**Demolition and Construction of the Wayside Trail, City of Waltham Portion**

**ADDENDUM NO. 2**

January 12, 2022

STATE	FED. AID PROJ. NO.	SHEET NO.	TOTAL SHEETS
MA	-	03	114
PROJECT FILE NO.		XXXXXX

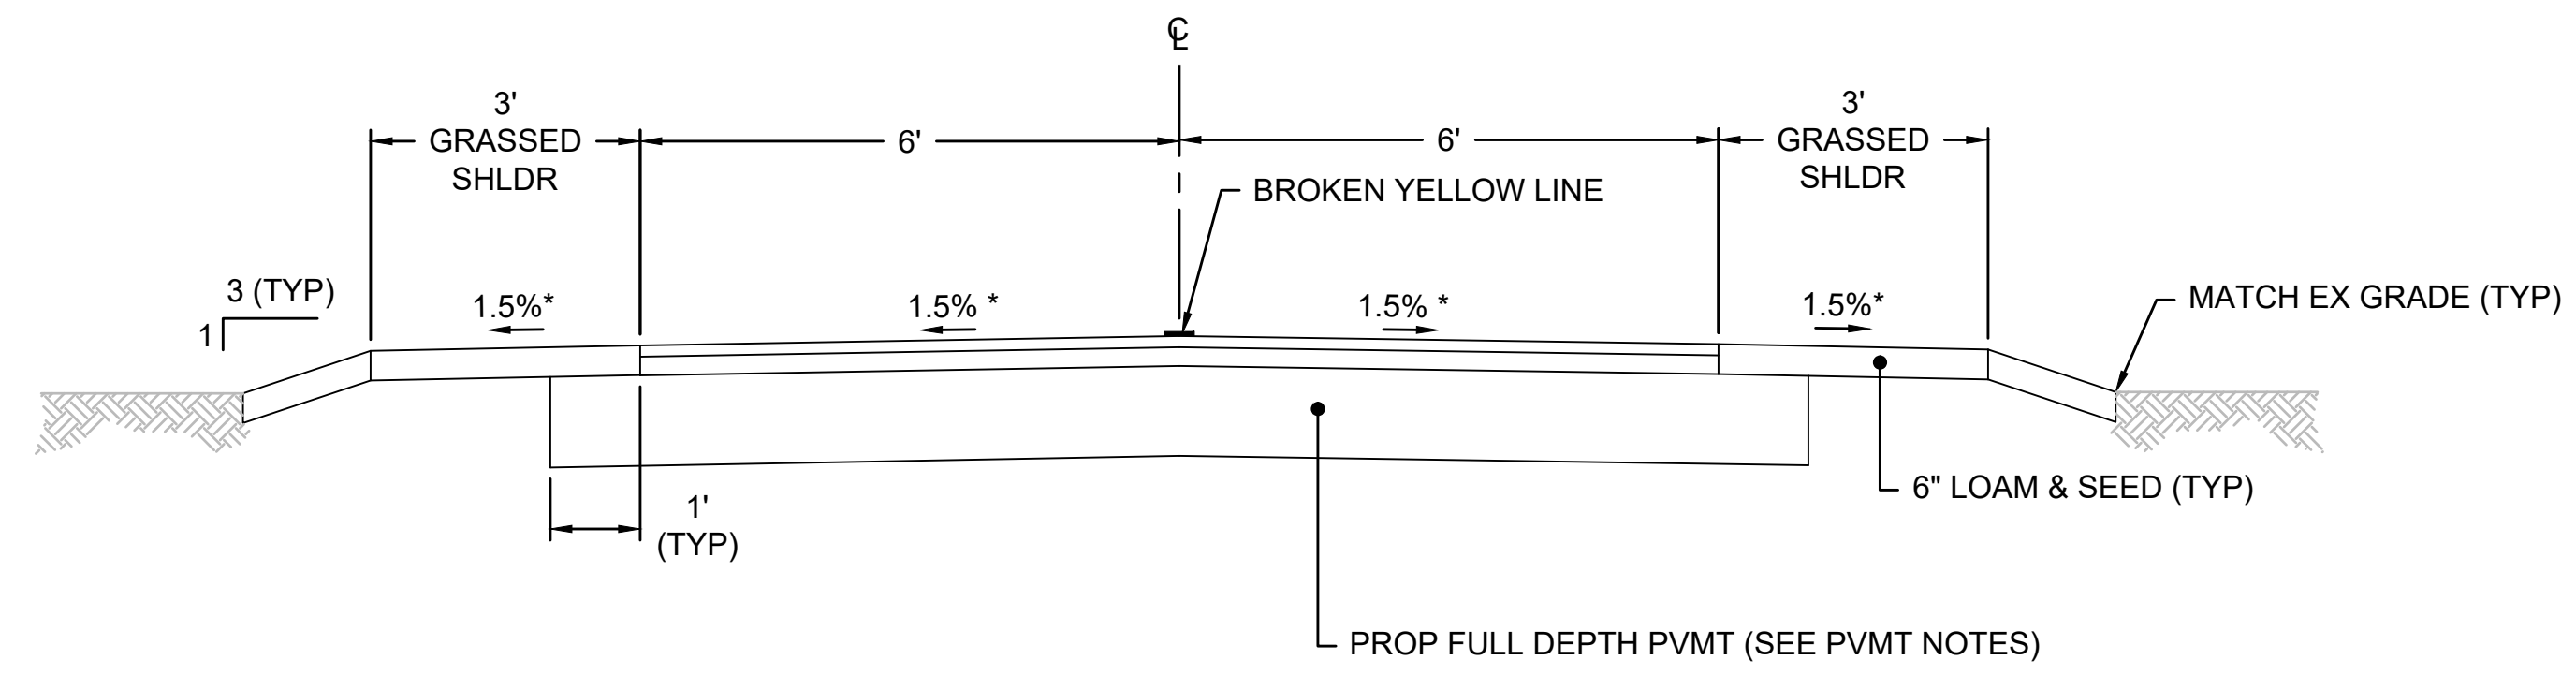
**Q8.** Refer to Electrical Notes 1 and 2 on drawing # 03, PVC electrical conduit and handholes are called out to be installed for the length of the trail for potential future lighting; this conduit is also shown within the typical section on drawing # 06. There are no unit price bid items for the conduit or the handholes. Please inform where this work is to be carried in the bid and also please provide more detailed electrical drawings that show conduit layout, handhole locations, and also provide details for how the conduit is to be installed on the proposed bridge structures.

**Q10.** Refer to Grading and Utility Note 16 on drawing # 03, which informs that the Contractor is responsible for cleaning out existing catch basins and piping prior to commencing with work. Being that the extent of the existing accumulated sediment is unknown, please provide appropriate unit price bid items to compensate for this work.

**A8.** Based on final coordination with DCR, elements for lighting have been removed from the contract. Revised Notes and Typical are attached. There are no changes to the bid form.

**A10.** The City will perform this work; bidders should not include this effort in their bid.

STATE	FED. AID PROJ. NO.	SHEET NO.	TOTAL SHEETS
MA	-	06	114
PROJECT FILE NO.		XXXXXX

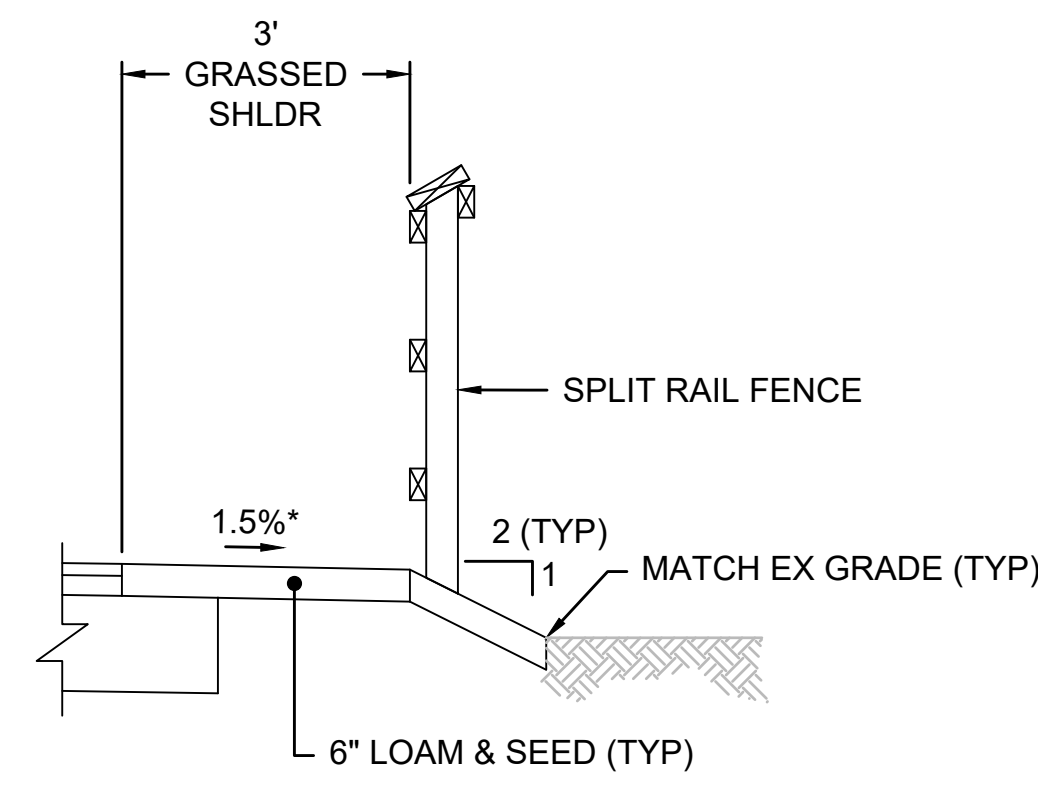
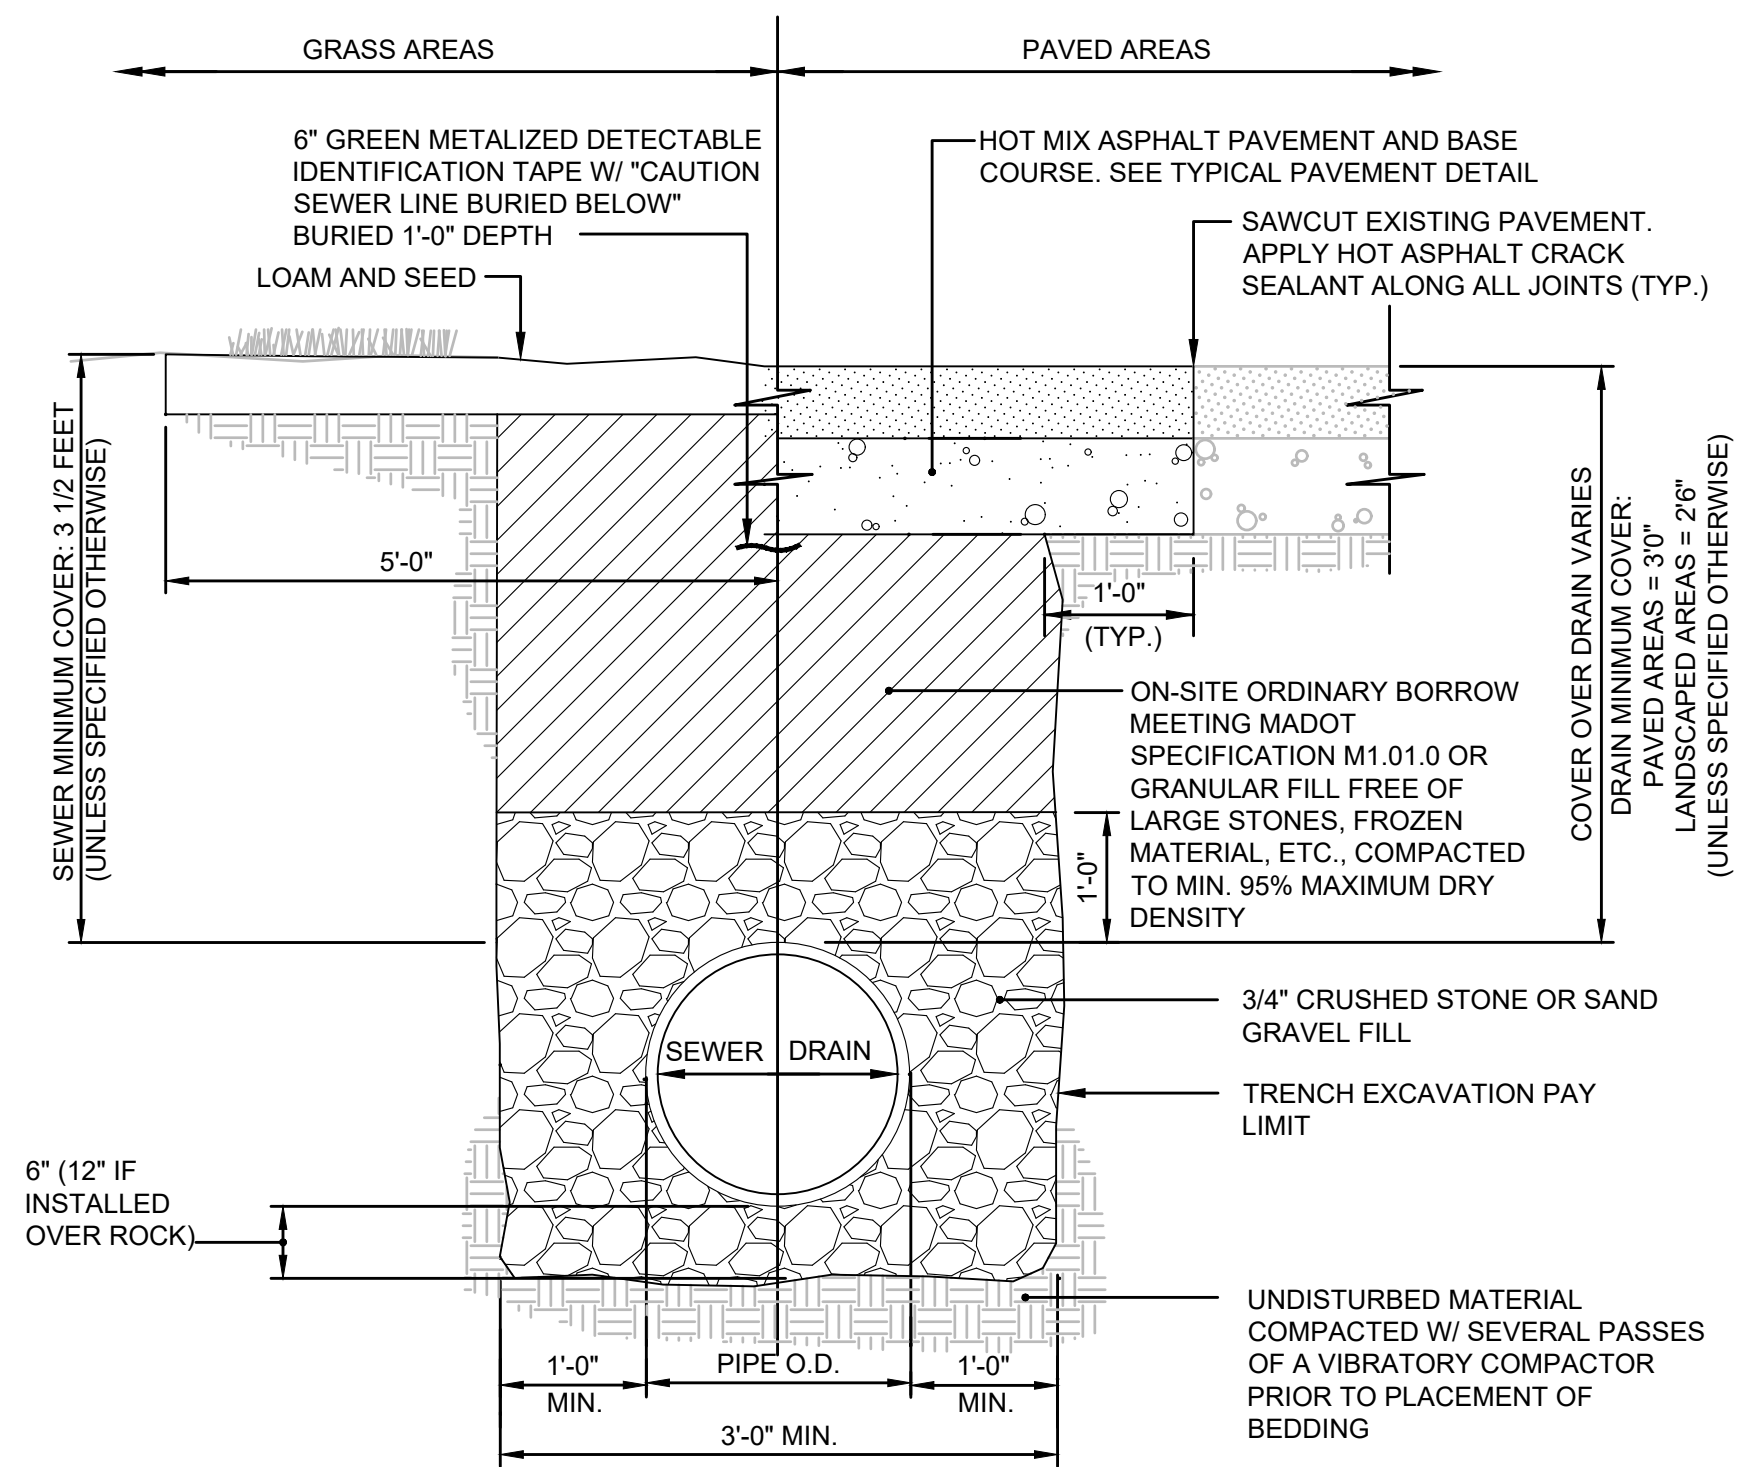
**Q32.** Could you please advise as to where the 3" PVC Electrical Conduit for future lighting is paid? Refer to the typical "Trail" section detail shown on drawing # 6 of 114.

**A32.** Based on final coordination with DCR, elements for lighting have been removed from the contract. Revised Notes and Typical are attached. There are no changes to the bid form.

STATE	FED. AID PROJ. NO.	SHEET NO.	TOTAL SHEETS
MA	-	49	114
PROJECT FILE NO.		XXXXXX

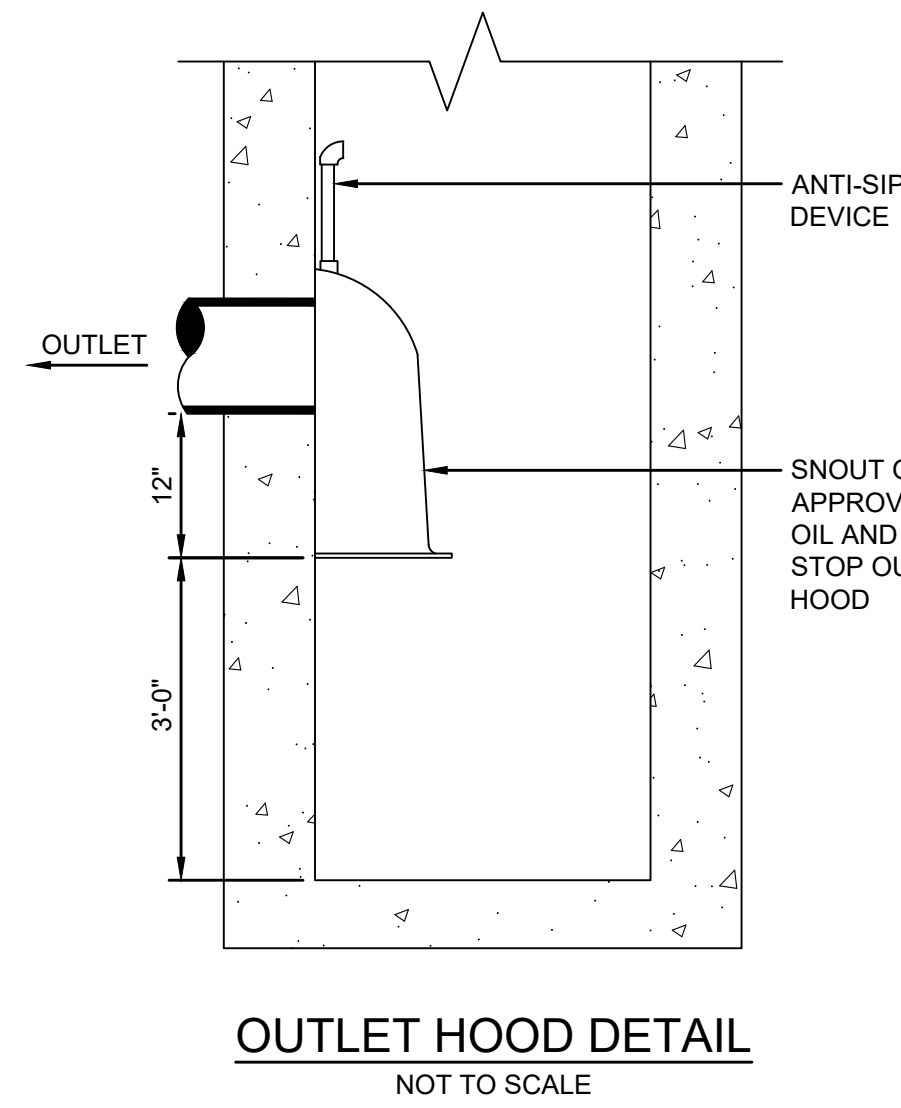
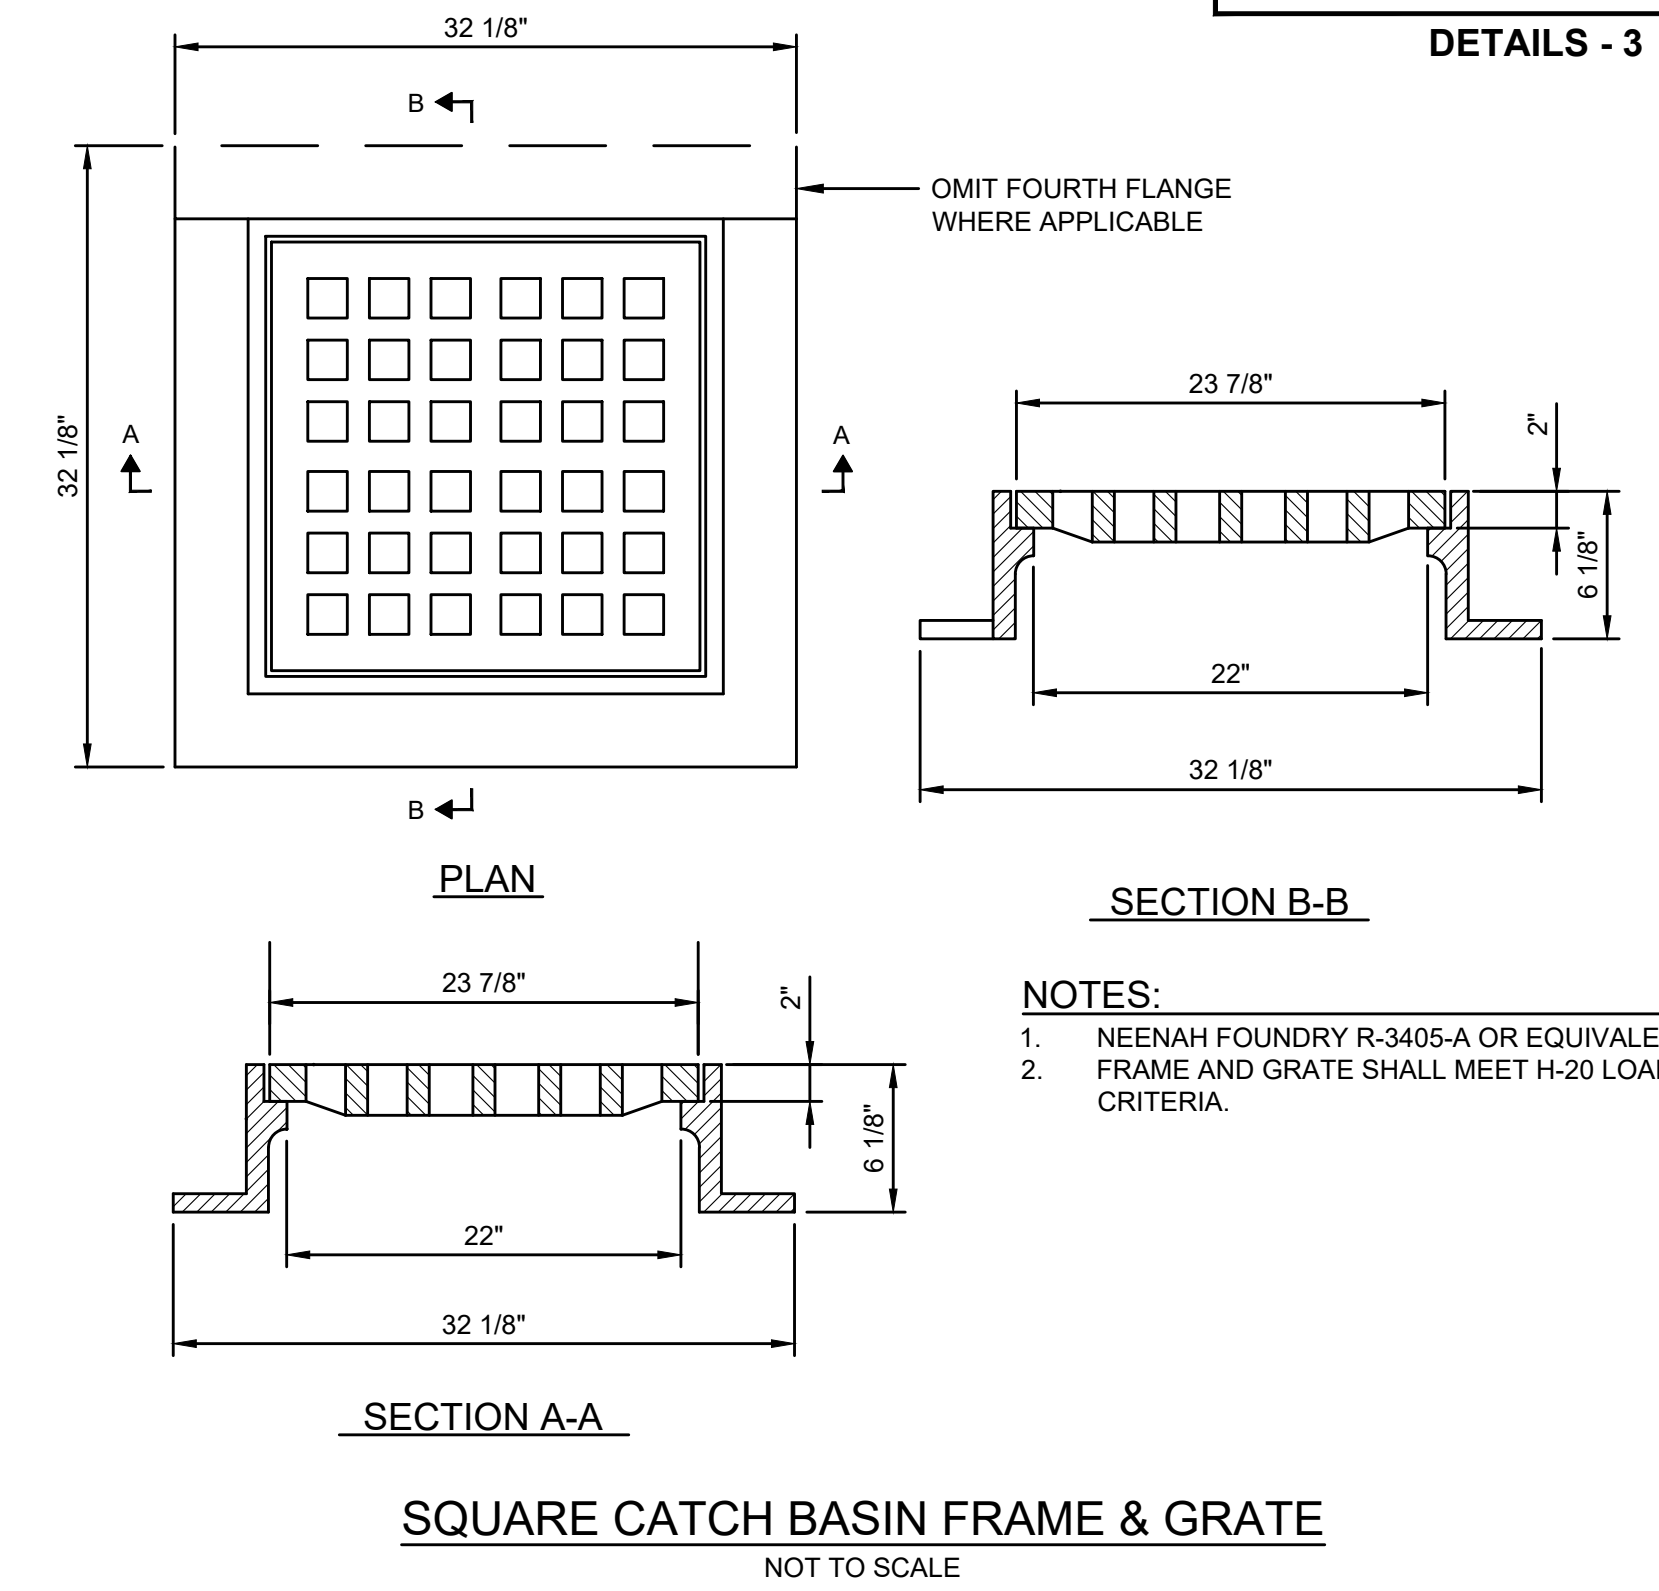
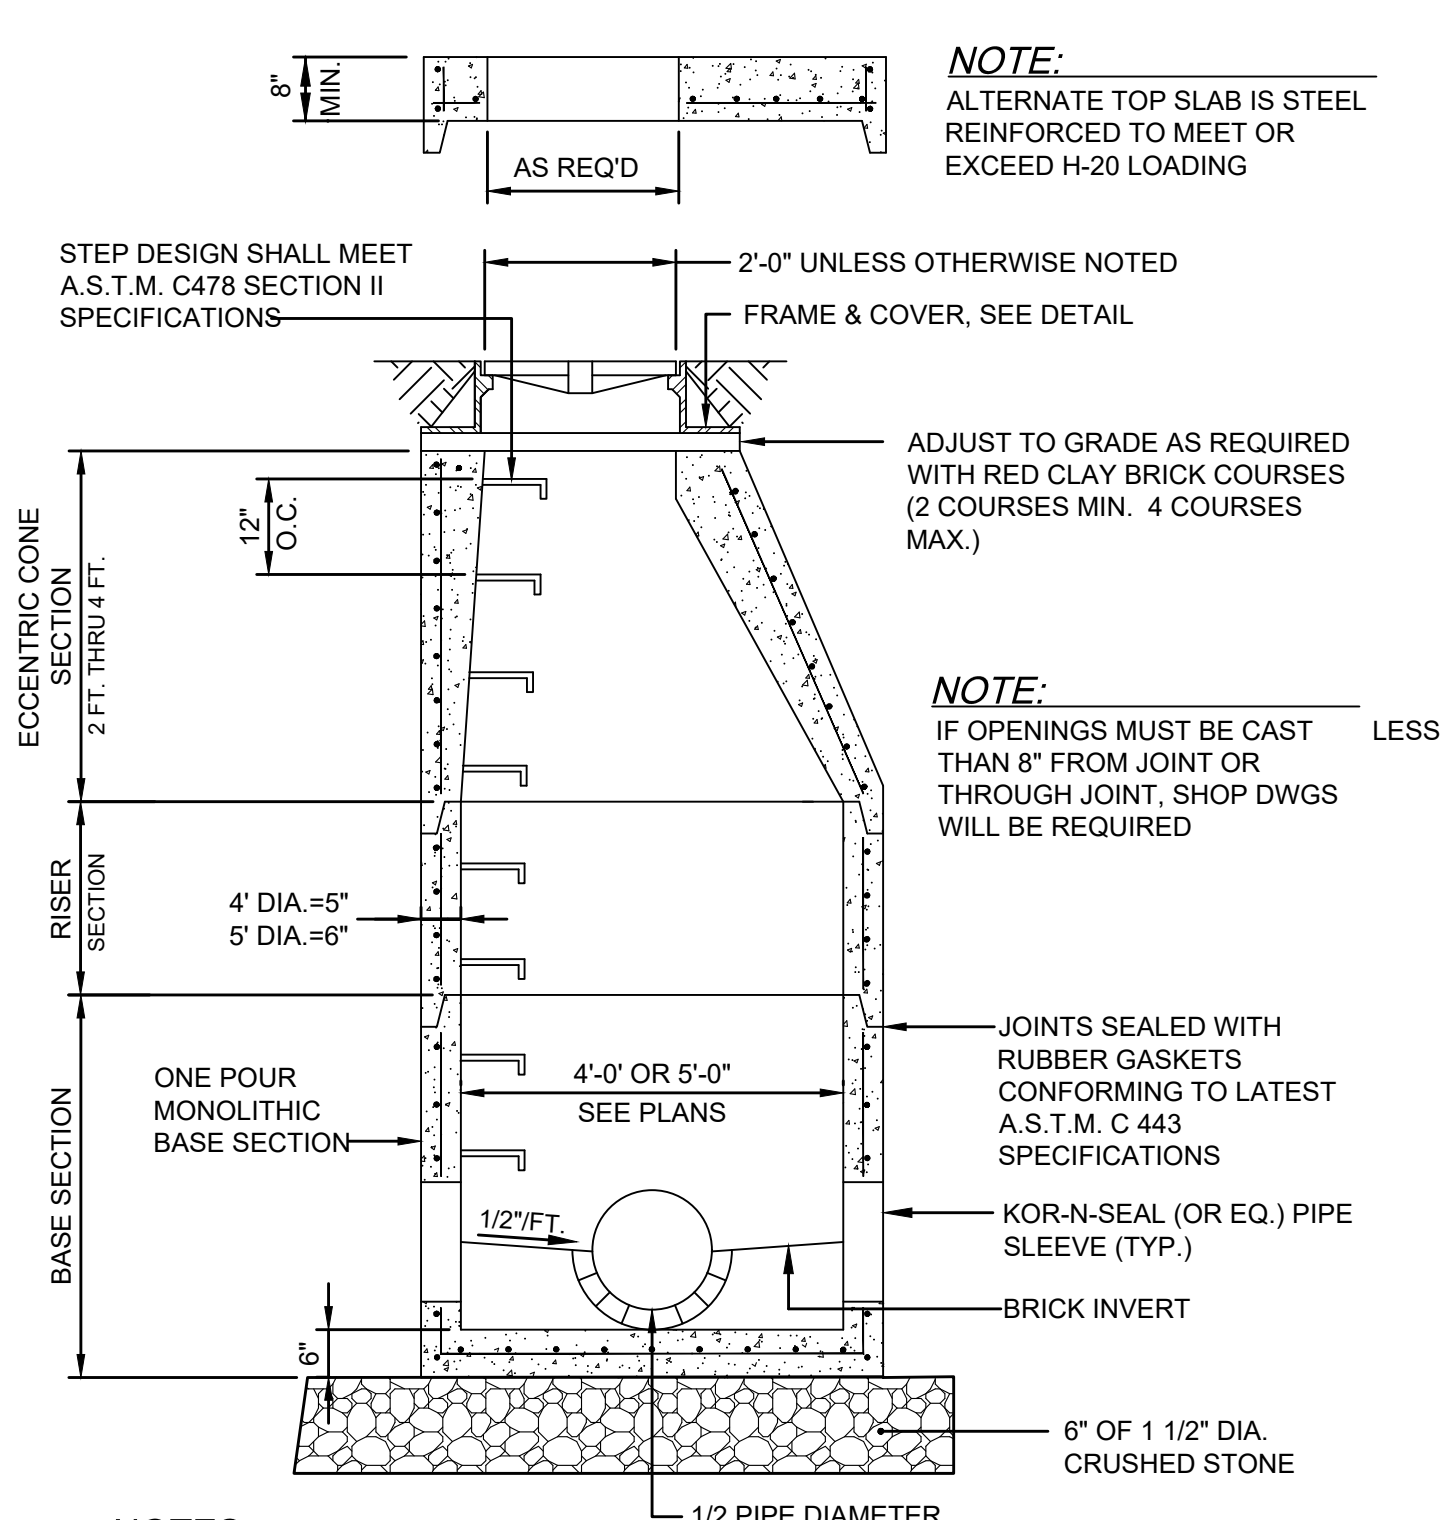
**Q24.** Refer to drawing # 49, there is a detail to the left of the “Outlet Hood Detail” that did not plot. Please provide this missing detail.

**A24.** See attached for revised sheet 49 which shows the detail for Precast Concrete Catch Basin (with Hood).
